YANKEE ATOMIC ELECTRIC COMPANY

June 20, 2006
BYR 2006-049

Enclosure: Rev. 18 to the ODCM

YANKEE NUCLEAR POWER STATION
OFF-SITE DOSE CALCULATION MANUAL

Figure 1-1
Yankee Nuclear Power Station
Site Boundary Lines

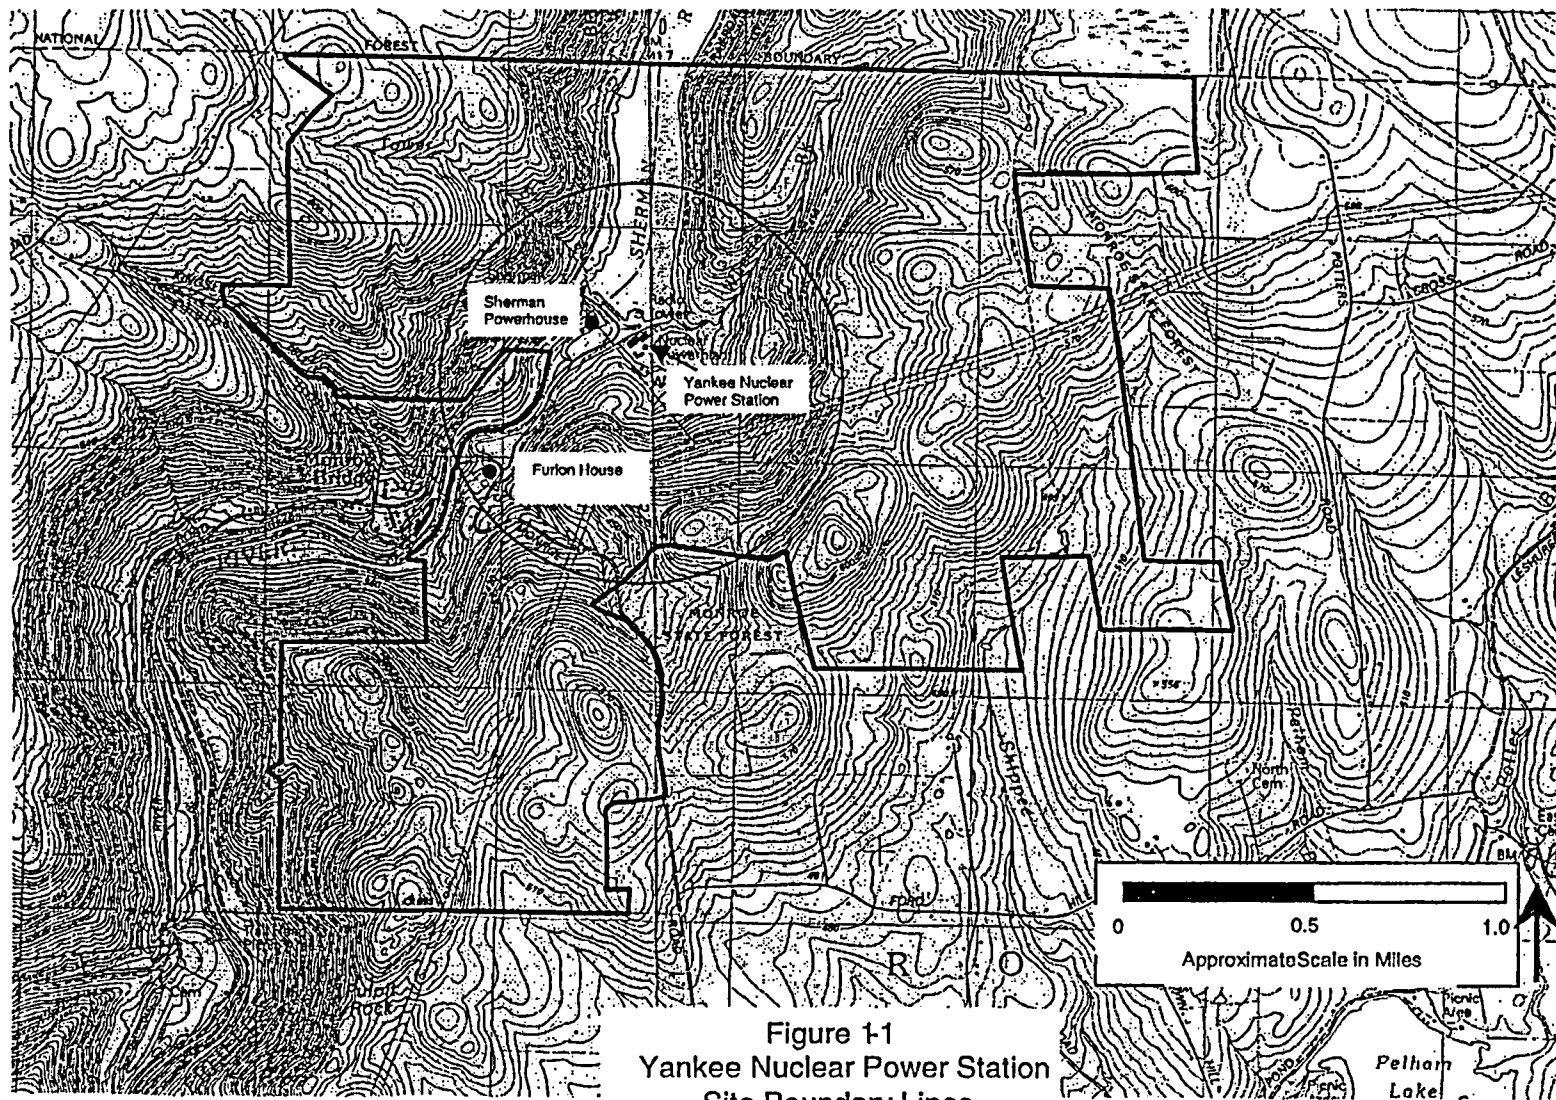
1. Revise existing Figure 1-1 to remove the previous exclusion area boundary and to rename the figure as Figure 1-1a.
2. Add a Figure 1-1b to show the new exclusion area boundary (ISFSI exclusion area boundary) and to show the new (and smaller) boundary for the portion of the site that remains under the 10 CFR Part 50 license. It is noted that the definition of "SITE BOUNDARY" and the site boundary depicted are not affected by this revision.
3. Remove the reference to air particulate sampler (DAP-2) located on the ISFSI pad (reference in the footnotes on Table 4.4).

Revising the Site Boundary figure to remove the previous exclusion area boundary (for the power generating plant, which has since been removed and associated effluents and release have been terminated) and adding a figure to correctly depict the new exclusion area associated with the ISFSI do not impact any monitoring requirements or dose calculation methodologies. Thus, these changes do not reduce the effectiveness of the ODCM.
